# Access Compliance Report

## Public Rights-of-Way

### (Curb Ramps)

Intersection ID: 43765	Main Street: HELENS_LN	Cross Street: EASTFIELD_RD	Location: SE
ADA ID: 92B1FBD45439	Ramp Type: Perp	Initial Pass/Fail: Fail	Overall Compliance: No
		Severity Score: 35

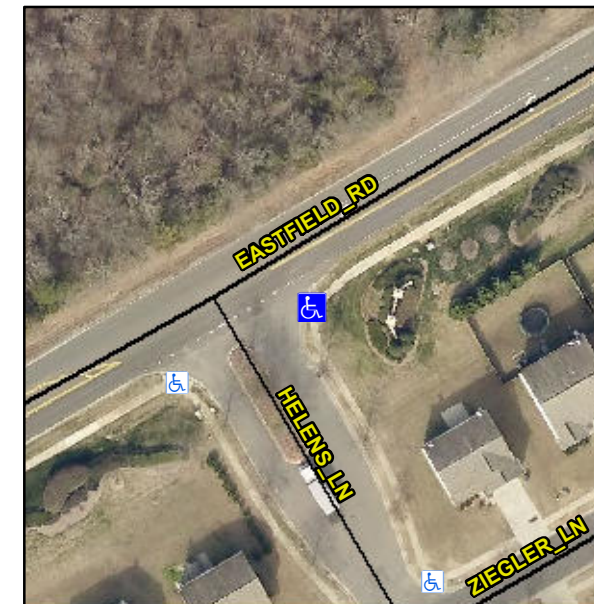
**R304.5.1, R304.2.2, R304.5.3**

Compliance	Description	Data	Compliance	Description	Data
N/A	Ramp Length (in)	48.0	No	Ramp Slope (%)	12.3
No	Ramp Width (in)	40.0	No	Ramp XSlope (%)	3.2
N/A	Flare Type LT	N/A	N/A	Flare Type RT	N/A
N/A	Flare Slope LT (%)	N/A	N/A	Flare Slope RT (%)	N/A
N/A	Flare Traversable LT?	N/A	N/A	Flare Traversable RT?	N/A
N/A	Landing Length (in)	N/A	N/A	DWS Provided?	N/A
N/A	Landing Width (in)	N/A	N/A	DWS Contrast?	N/A
N/A	Landing Slope (%)	N/A	N/A	DWS Length (in)	N/A
N/A	Landing X Slope (%)	N/A	N/A	DWS Full Width?	N/A
N/A	Landing Curb? (Y/N)	N/A	N/A	DWS Offset (in)	N/A
N/A	Shared Landing?	N/A			
N/A	Gutter Ponding?	N/A	N/A	Gutter Slope (%)	N/A
N/A	Gutter Lip Ht (in)	N/A	N/A	Gutter X Slope (%)	N/A
N/A	Painted X Walk1?	No	N/A	Painted X Walk2?	N/A
	X Walk 1 Direction	To SW		X Walk 2 Direction	N/A
N/A	X Walk 1 Width (in)	N/A	N/A	X Walk 2 Width (in)	N/A
	X Walk 1 Slope (%)	3.3		X Walk 2 Slope (%)	N/A
	X Walk 1 X Slope (%)	3.0		X Walk 2 X Slope (%)	N/A

**Remove & Replace Entire Ramp.**
